ESTERO DESIGN REVIEW COMMITTEE

Public Meeting
December 17, 2014 at 5:00 PM
The Estero Recreation Center
9200 Corkscrew Palms Blvd.

APPLICANT: Marriot at Coconut Point
Location of Project: Coconut Point DRI
Presented by: Tom McLean – Hole Montes Associates

Originally presented to
EDRC on
December 17, 2014

EDRC/Public Responses – Site Plan

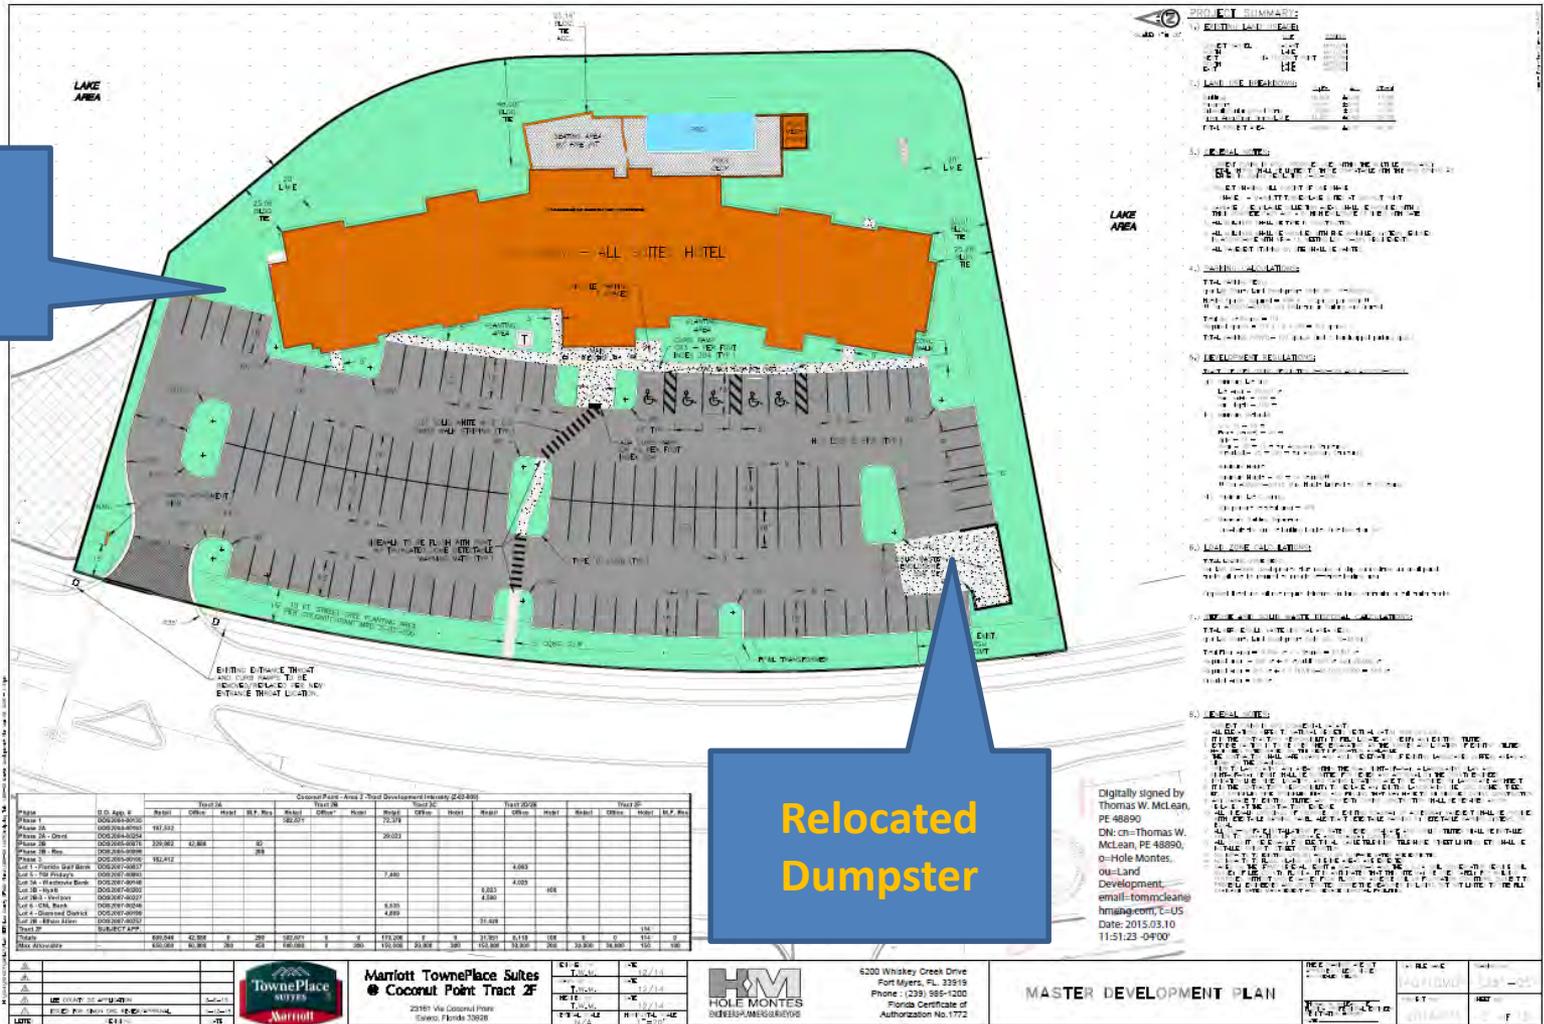
Tom McLean Civil Engineer presented the Site Plan. EDRC/Public took exception to the site plan layout that placed the dumpster location in primary view of anyone entering the project site. The Applicant's response that gates in front of the dumpster would suffice was not found sufficient by the EDRC/Public. This dumpster location should be elsewhere on the property and not the primary focus of a customer coming into the site. This is not appropriate site planning for Estero.

Applicant Response:

We have revised the site plan to accommodate the dumpster location as requested. The dumpster enclosure has been relocated to the south end of the parking area.

EDRC – Site Comments

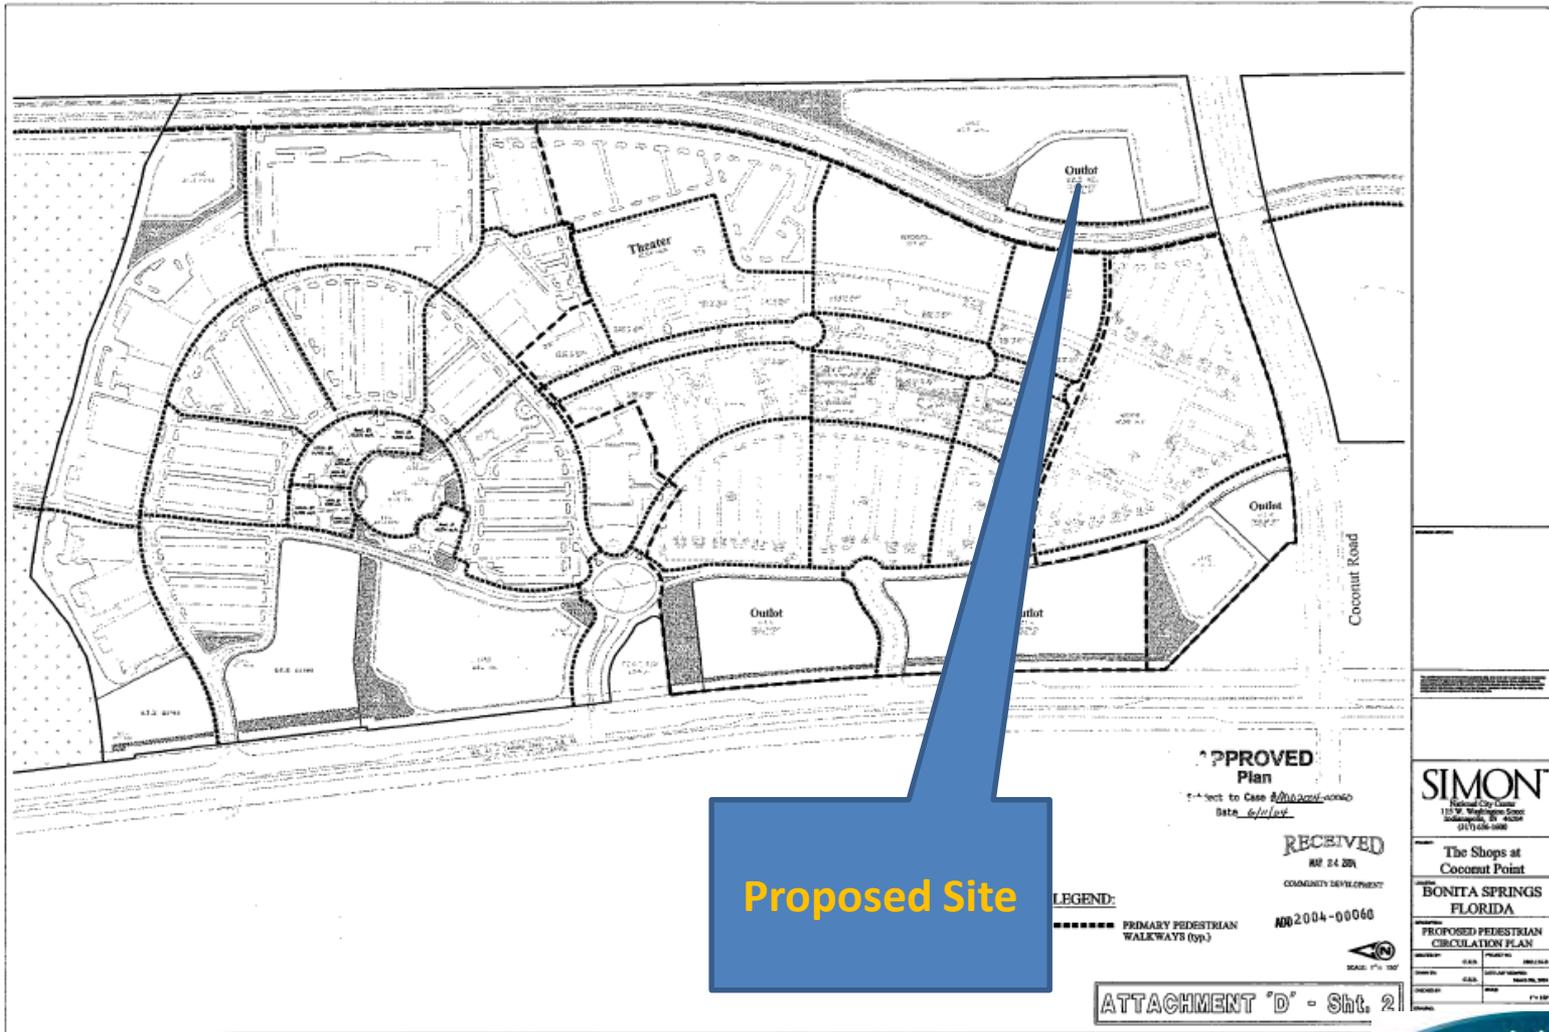
Pedestrian interconnection; The Applicant noted that Lee County was resistant to providing a protected pedestrian crosswalk across Via Coconut Point. The EDRC/Public, noting the years of effort and current proposals to code to make all projects pedestrian friendly, found the lack of a protected pedestrian crosswalk from the project to the Coconut Point Mall unacceptable. The appropriate infrastructure for a pedestrian crossing from this project to Coconut Point needs to be made especially in light of the fact that this project is an extended stay facility. Forcing pedestrians to walk south the Coconut Road and then back north to the Mall is an unacceptable and unreasonable solution.

Applicant Responses:

With respect to Pedestrian Connectivity, the project is part of the Coconut Point DRI, which has an approved pedestrian connectivity plan. The Site Plan follows the DRI approved plan and on-site side walks are connected to the overall surrounding plan. The request for a connection across Via Coconut Point Parkway constitutes a mid block crossing, and would require a traffic signal to provide adequate public safety. The location considered is in the middle of a curved section of the roadway approaching Coconut Road to the south, which is the least safe location for a crossing. Finally, the road is a county owned and maintained roadway and the County would need to construct the crossing and take on the safety liability.

Revised Front Elevation

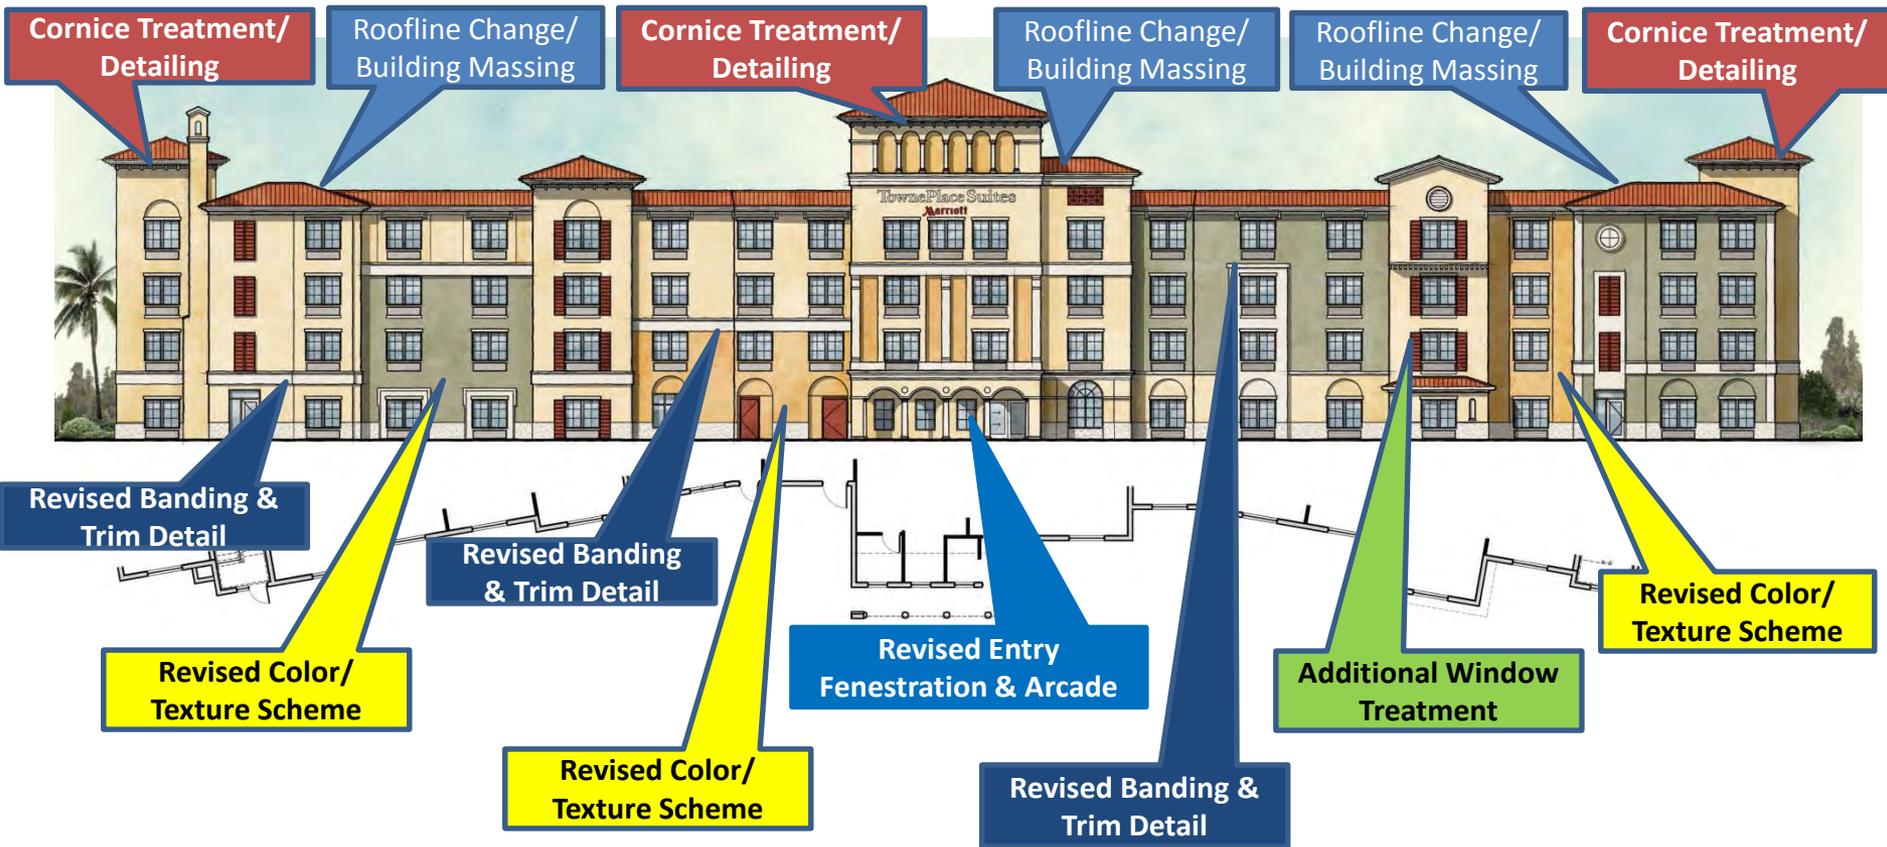
- Preliminary design to final design began with a Joe McHarris sketch. This worked well to create visual movement and dynamic spaces in the building to provide relief in the building.
- The EDRC/Public noted that the series of drawings presented by the Applicant from concept to final lessened the value, style, and design of the building in response to the required style in Estero along the way.
- The Final design as presented does not go far enough to meet the requirements of style based on the mass and form of the building.
- The EDRC/Public did commend the applicant about taking a symmetrical building and working to make it unsymmetrical details, but the final design has shed to many details in terms of roof line, material massing, and forms to found sufficient.

- The EDRC/Public asked about the parapets being removed and desired integrating that feature back into the design to better define the façade.
- This will provide the ability to make it look like 3 buildings versus one.
- There has been too much of a loss of symmetry at the entrance.
- The EDRC/Public felt that the initial conceptual design is what Estero mandates and the final design is bland anywhere USA.
- Creating the applications of the parapets illustrated in the conceptual sketch is a cost that isn't significantly greater, but without it, the details get lost and do not evoke the appropriate design style required in Estero.

- ❖ Window structure is lost
- ❖ Tower shutters lost detail
- ❖ Break up the banding/moving it across the line.
- ❖ Band get rid of....look at areas to break up the mansard so floor plans/tower heights/changes in detailing of middle tower

The elevations of the building have been revised to accommodate the comment and requests of the EDRC to the best extent possible.

EDRC/Public Responses – Signage

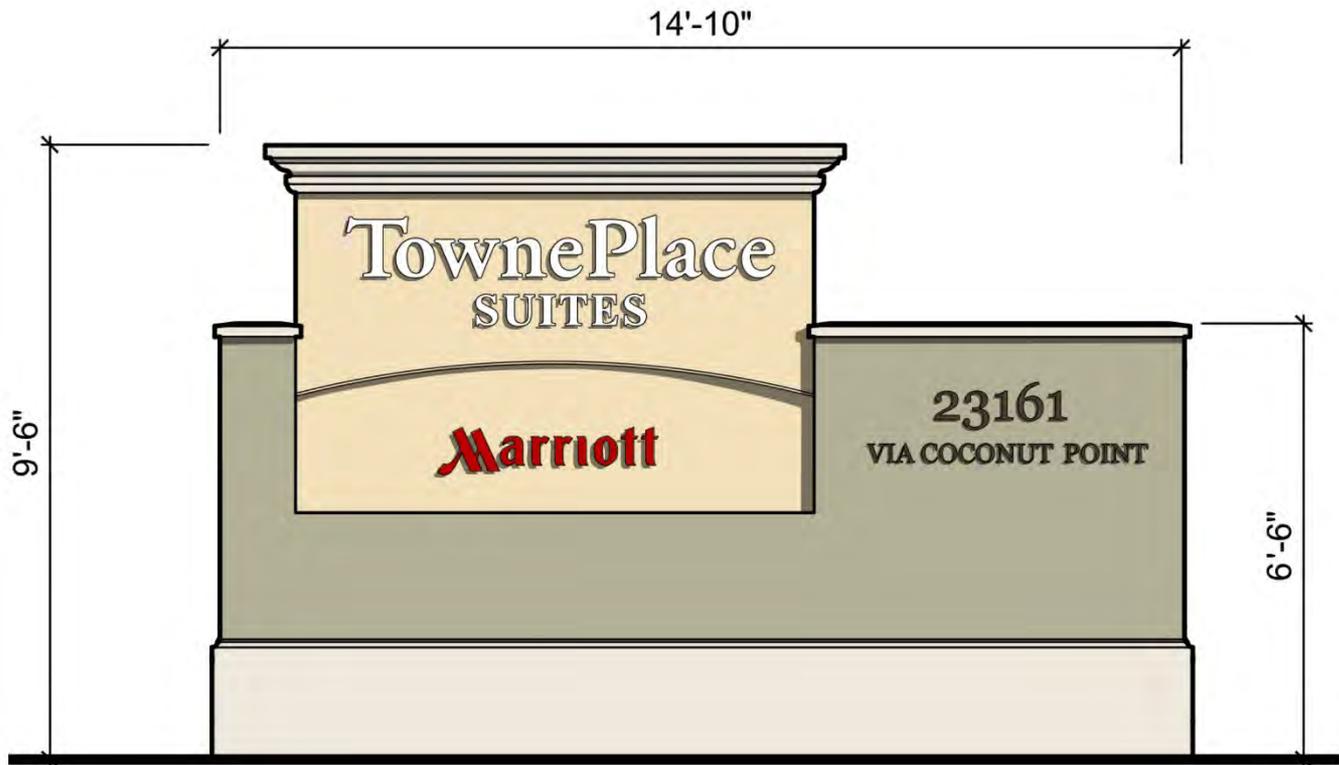
- Applicant conforms with Marriott prototype and the Estero requirements.
- Wall signage proposed each 64 sf in area.....Sign has been modified to blend into the surrounding area.
- The EDRC/Public noted that the base height is too small and EDRC was concerned about losing it with plantings.
- The EDRC/Public recommends **increasing the height to at least thirty-six inches** to better incorporate the proposed landscaping.

EDRC/Public Responses – Landscape Architecture

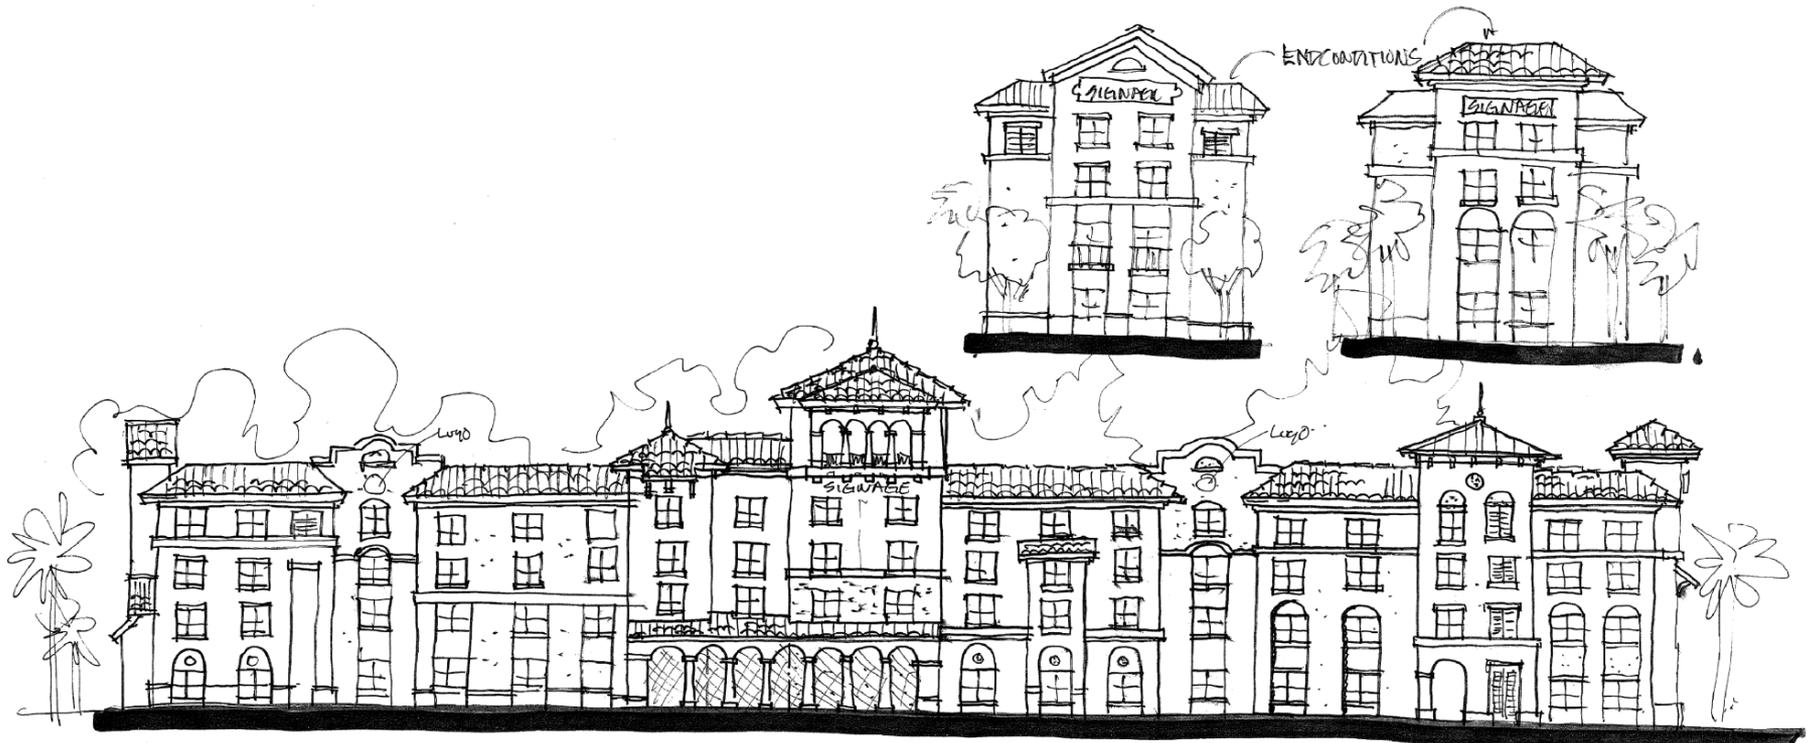
Greg Diserio, Landscape Architect presented the Landscape Design. All noted that the design was in compliance and exceeds required materials to buffers with added berming in front of the parking area to better shield the parking from the adjacent Via Coconut Point. Some material was added with larger heights mixed with smaller species to create a more human scale and transition for the pedestrian. EDRC specifically thanked the Applicant for increasing the density of the front buffer as committed to during public presentations to the ECPP. The buffer widths are 15' street tree planning buffer rather than 20' per the Coconut Point DRI.

The EDRC/Public asked about the dry detention area north of the project as being a current eye sore... if the Applicant or if Simon was going to increase or do something.....south edge also... Nothing was assured or resolved in this matter as it is off of the Applicant's property.

The dry detention area to the north is currently owned and maintained by the Coconut Point – Area 2 Property Owners Association. We do not have the ability to make changes to this area.

Revised Front Elevation

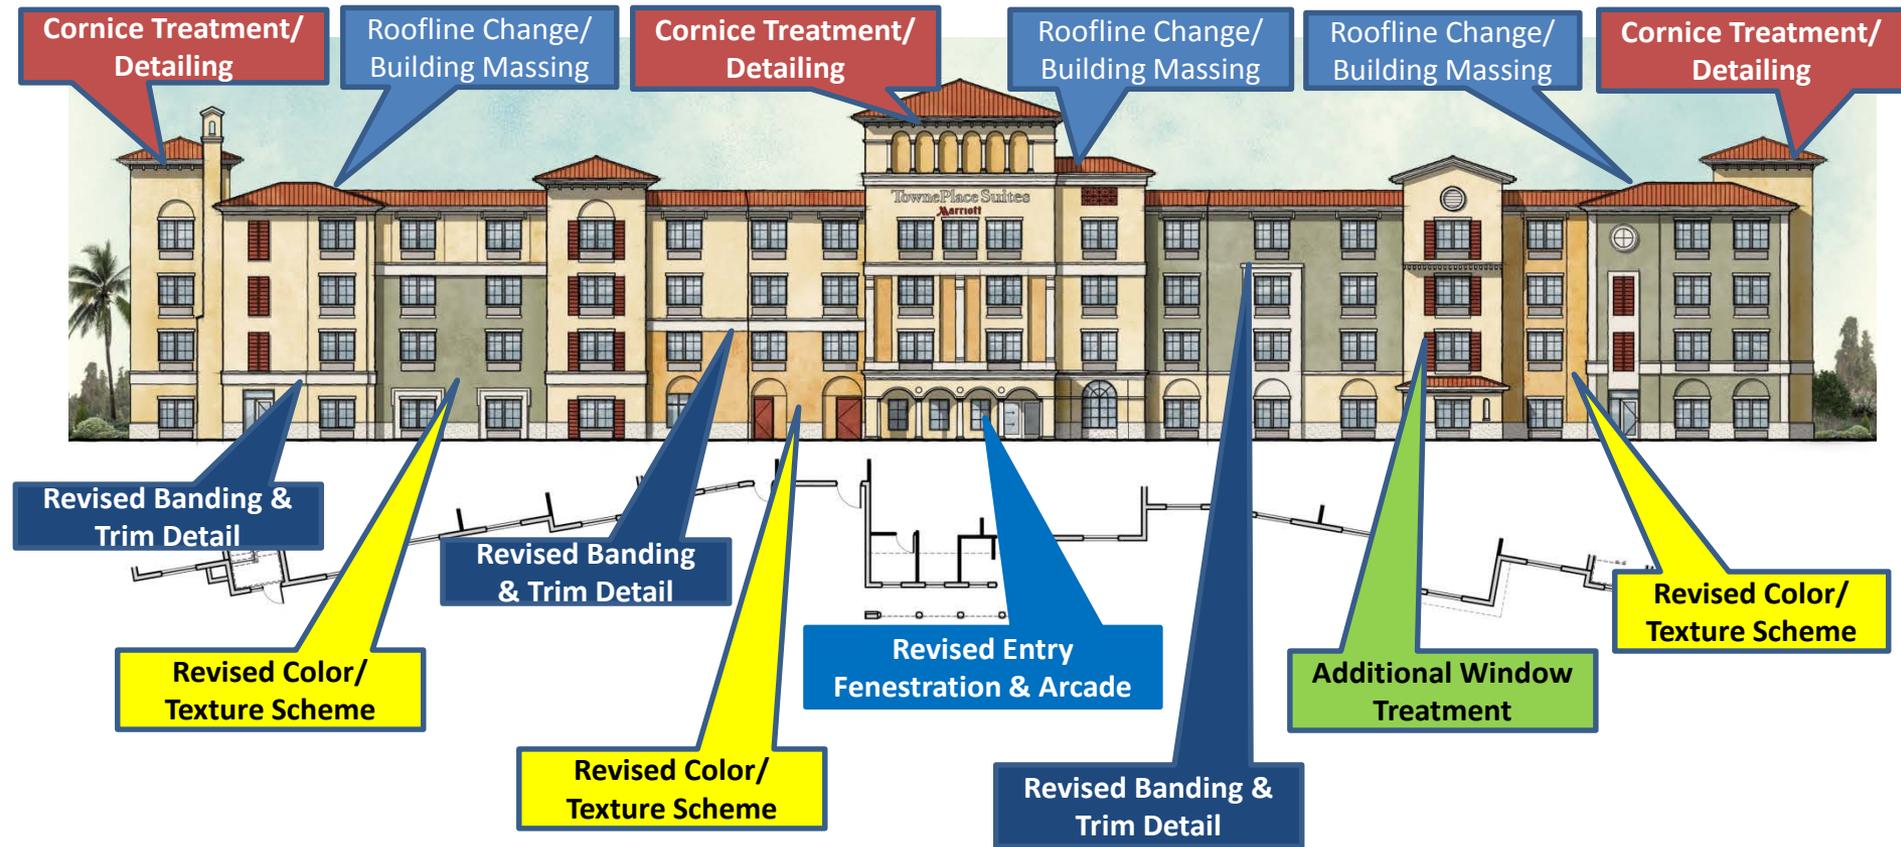
- Preliminary design to final design began with a Joe McHarris sketch. This worked well to create visual movement and dynamic spaces in the building to provide relief in the building.
- The EDRC/Public noted that the series of drawings presented by the Applicant from concept to final lessened the value, style, and design of the building in response to the required style in Estero along the way.
- The Final design as presented does not go far enough to meet the requirements of style based on the mass and form of the building.
- The EDRC/Public did commend the applicant about taking a symmetrical building and working to make it unsymmetrical details, but the final design has shed to many details in terms of roof line, material massing, and forms to found sufficient.

- The EDRC/Public asked about the parapets being removed and desired integrating that feature back into the design to better define the façade.
- This will provide the ability to make it look like 3 buildings versus one.
- There has been too much of a loss of symmetry at the entrance.
- The EDRC/Public felt that the initial conceptual design is what Estero mandates and the final design is bland anywhere USA.
- Creating the applications of the parapets illustrated in the conceptual sketch is a cost that isn't significantly greater, but without it, the details get lost and do not evoke the appropriate design style required in Estero.

- ❖ Window structure is lost
- ❖ Tower shutters lost detail
- ❖ Break up the banding/moving it across the line.
- ❖ Band get rid of....look at areas to break up the mansard so floor plans/tower heights/changes in detailing of middle tower

The elevations of the building have been revised to accommodate the comment and requests of the EDRC to the best extent possible.
